United States Department of the Interior

October 6, 2015

Subject: Review of Draft Environmental Impact Statement for the Proposed Oregon Liquefied Natural Gas Terminal and Pipeline Project and the Washington Expansion Project (Docket Nos CP09-6-000, 001; CP09-7-000, 001; CP13-507-000)

Figure 1: Eastern Boundary of Lewis and Clark National Historical Park (in yellow) in Relation to Pipeline Route

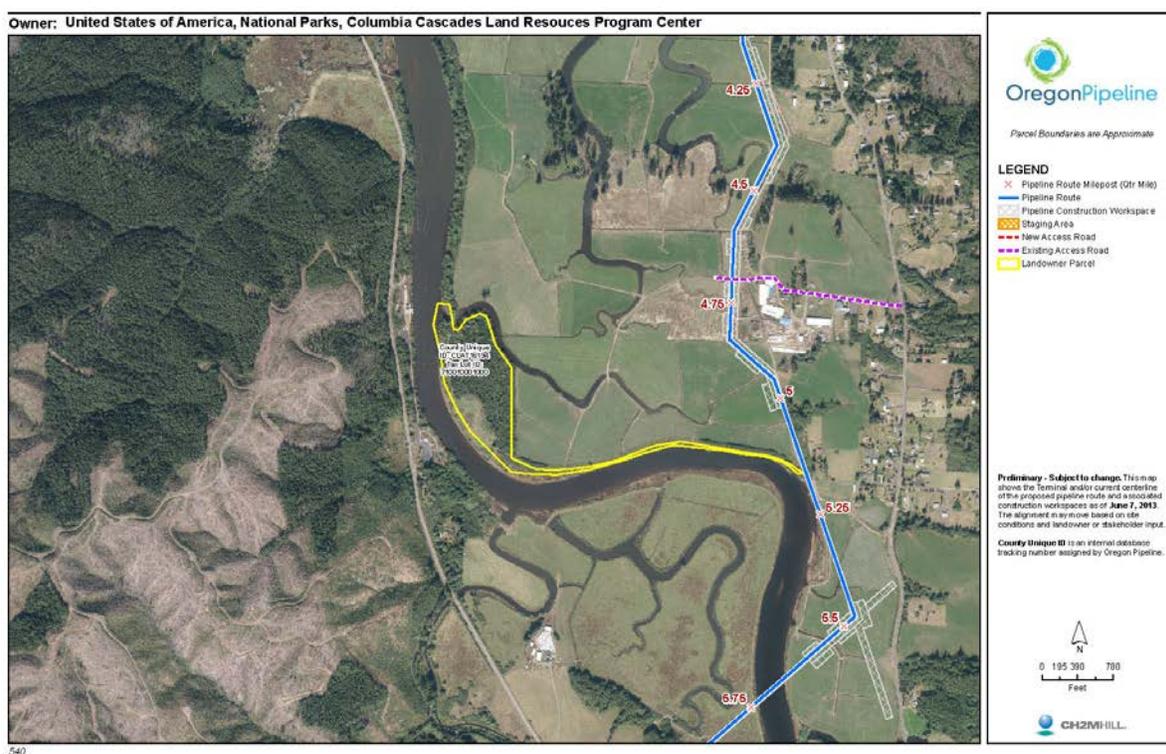
There is the potential for adverse effects to the archaeological and historic resources of Lewis and Clark National Historical Park. The DEIS states “The easternmost boundary for the LCNHP is located about 0.6 mile west of the direct effects APE” (page 4-320). This may be in reference to the old boundary of the park, before the 2005 expansion. It is correct that the lands of Lewis and Clark National Historical Park listed on the National Register are approximately 0.6 miles from the pipeline; however, the taxlot owned by the park closest to the pipeline is 710010001000, which includes lands along the bank of the Lewis and Clark River. The pipeline centerline is approximately 95 feet from the easternmost boundary of Lewis and Clark National Historical Park, near MP 5.2 (The previous estimate of 30 feet in the NPS letters of November 7, 2012, and July 9, 2015, was based on an Oregon LNG-generated parcel map; the updated distance was measured on the ground using the detailed waterbody crossing design maps in Appendix G). The park boundary was surveyed in 2005 by the Bureau of Land Management. The survey maps and notes are available at: <https://www.glorerecords.blm.gov/default.aspx>.

Part of Lewis and Clark National Historical Park is therefore within the direct effects APE (300 feet wide) as well as the indirect effects APE (1 mile). The national park lands within the direct effects APE have not yet been surveyed for historic and archaeological resources.

D). The Lewis and Clark site at Middle Village - Station Camp (45PC106) was recorded as an archaeological site in 2010. Both are outside of the direct effects APE.

1. The text should be corrected to read: “there are two locations associated with the 1804-1806 Lewis and Clark expedition along the lower Columbia River that have been recorded as archaeological sites or listed on the national register for their archaeological resources. They are both outside of the direct effects APE.”
